Groundwater Transfer Review Summary Form

Transfer/PA # T- 14503

Application: T-14503

Applicant Name: Avion Water Company

Transfer Map

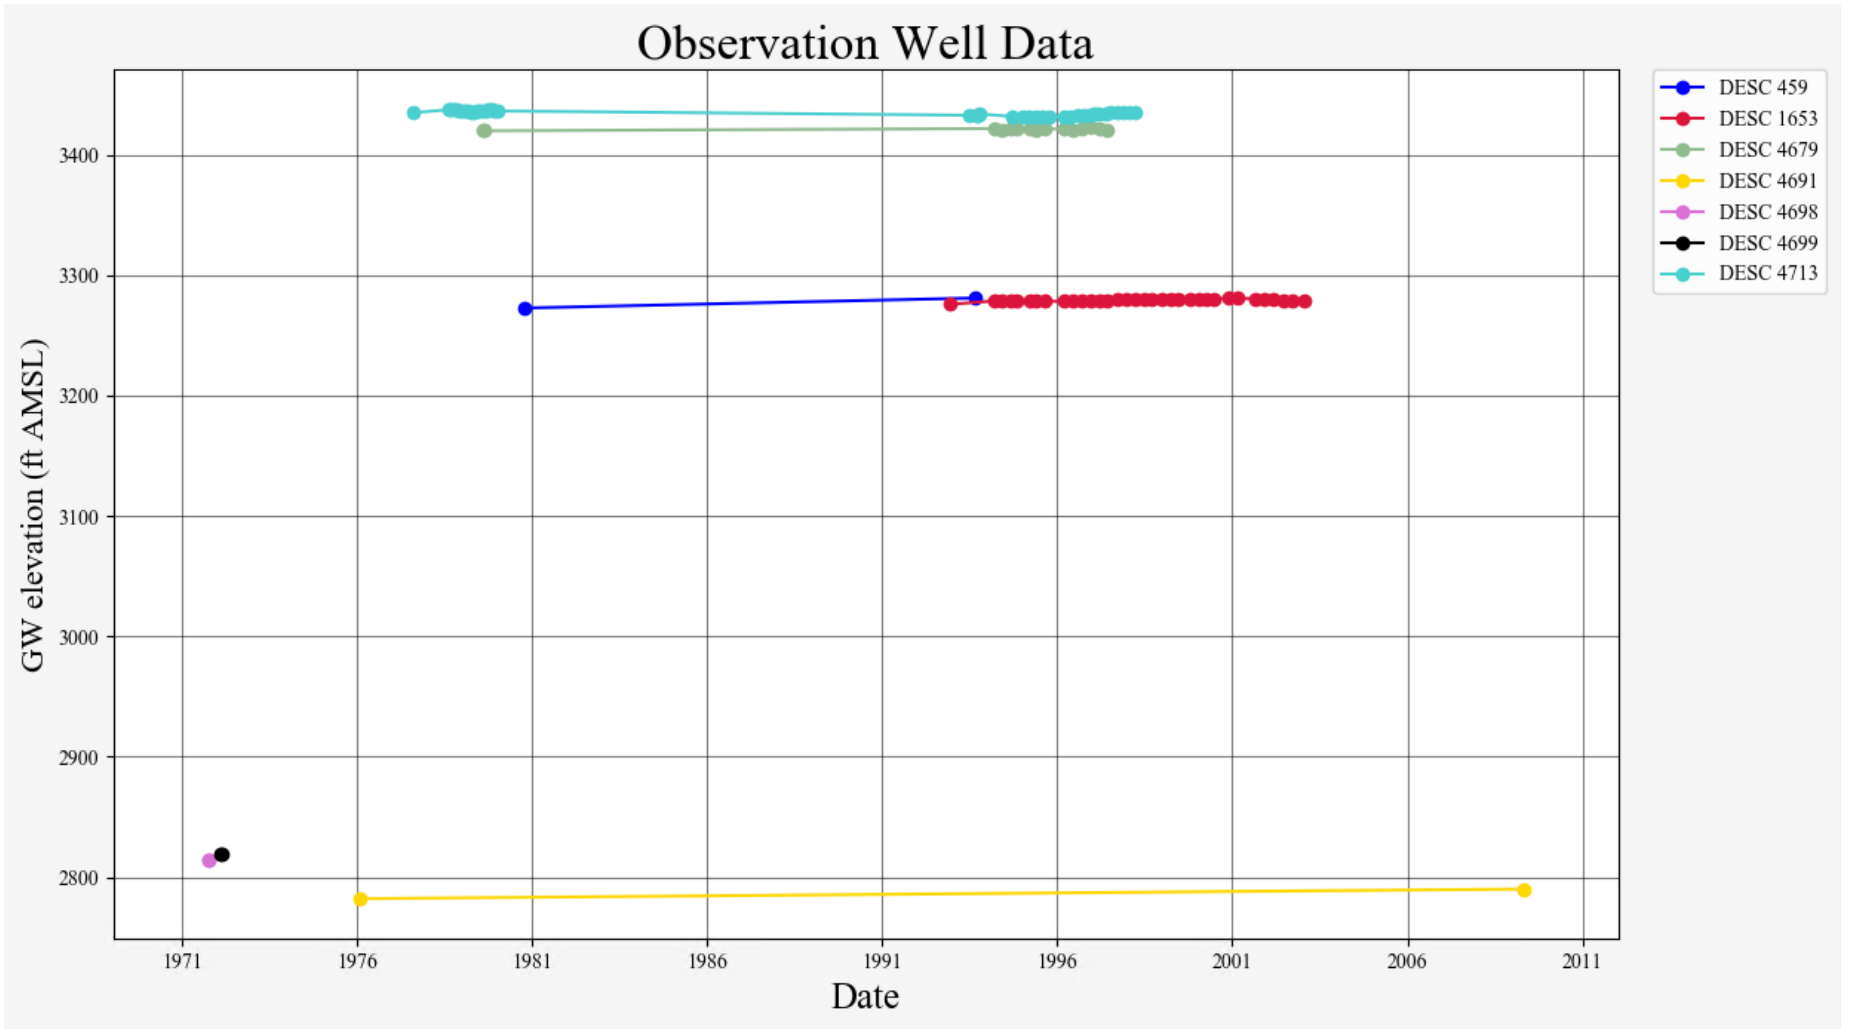
- 1. Basic description of the changes proposed in this transfer: Permit G-12766 authorizes 0.223 cfs of group domestic use from two wells (DESC 4699 & DESC 4698). This permit amendment proposes adding an undrilled APOA.

Yes No Comments: The APOA creates the possibility for a higher instantaneous pumping rate when DESC 4698 and the APOA are in operation, which could increase any well-to-well interference with wells in that area.

Yes No If yes, explain: There are no other exempt-wells or permitted wells within 1/4 mile of the applicant's wells. The target aquifer has typically high permeability/storage, low seasonal variability, and extends for several hundred feet below the depth of the APOA. Considering these factors, it is unlikely that any increase in well-to-well interference would be of high enough magnitude to be considered injury.

Water Levels in Adjacent Observation Wells

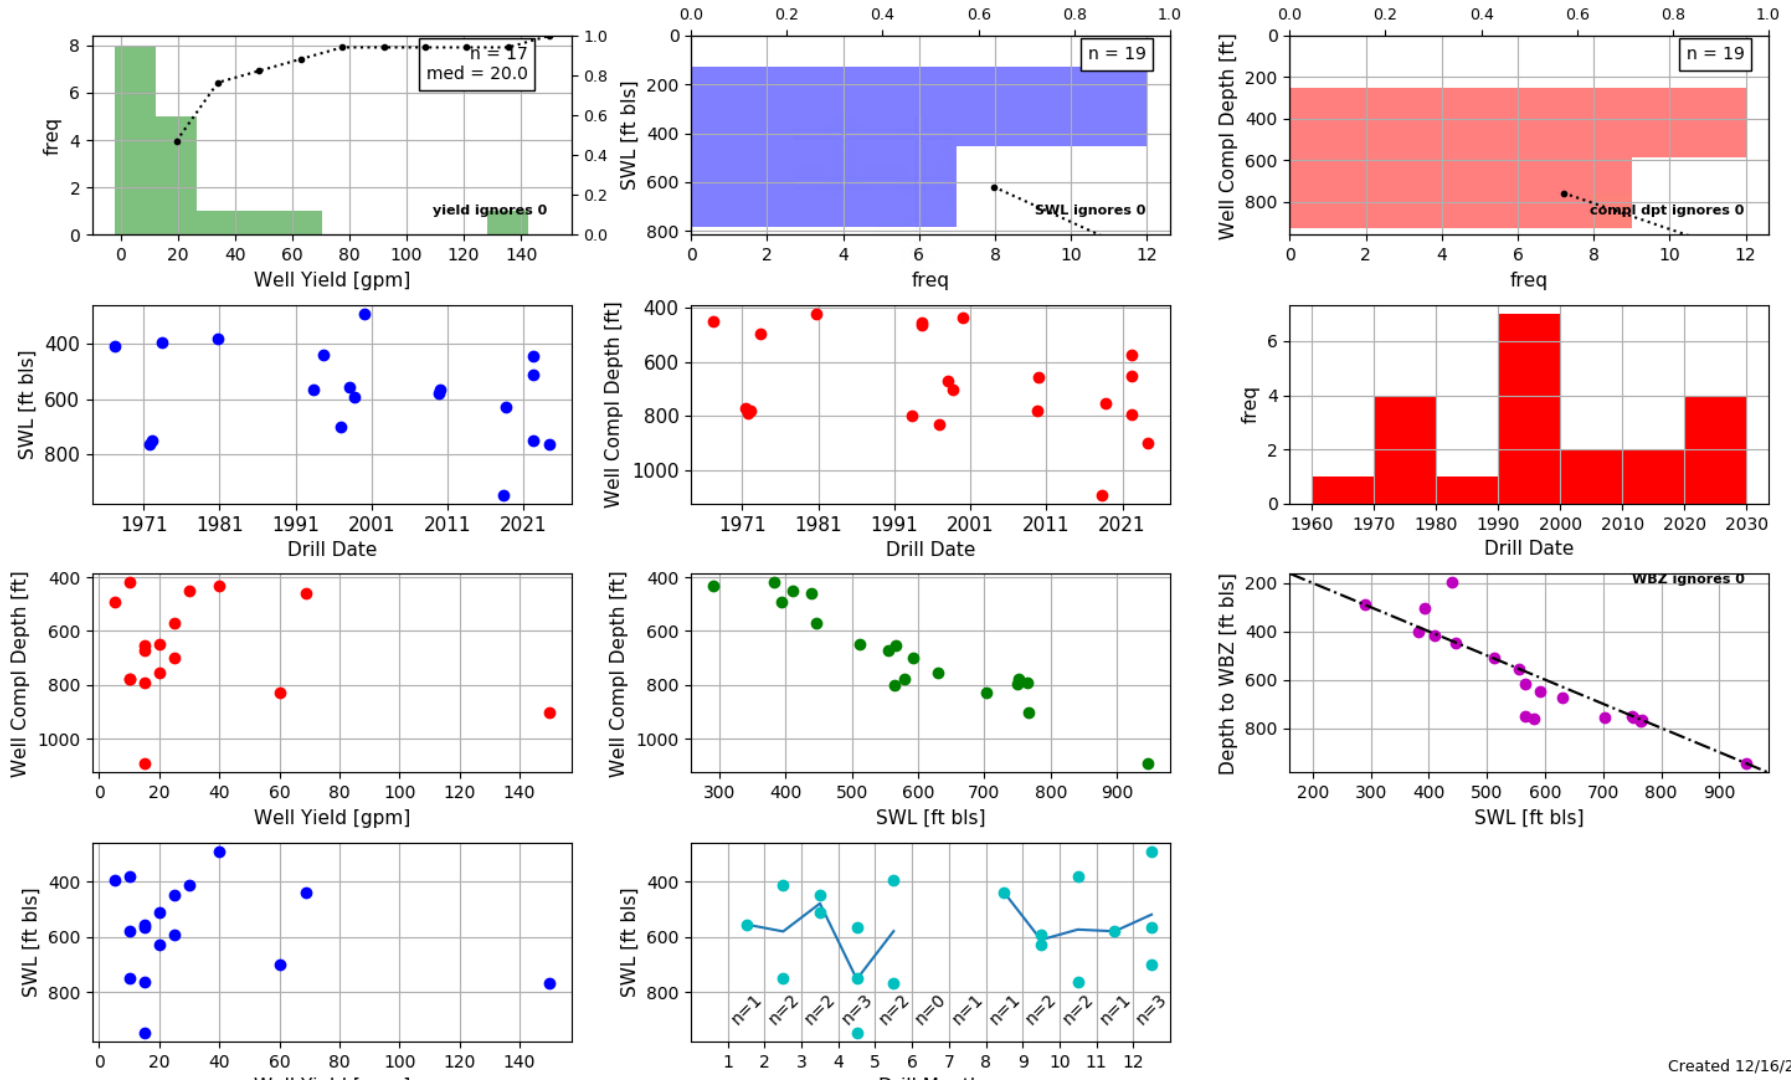
Yes No Comments: The current POAs and proposed APOAs have water level elevations of ~2800 feet amsl while the adjacent Tumalo Creek spans elevations of 3400-3600 feet amsl. While there is some local GW-SW flux on Tumalo Creek, the transfer wells access a deeper portion of the aquifer with flowpaths that do not impact surface water until the confluence area of the Deschutes/Crooked Rivers located 25+ miles to the north. Assuming there is no enlargement, the change in point of appropriation will have a negligible impact on the stream depletion that results from this permit.
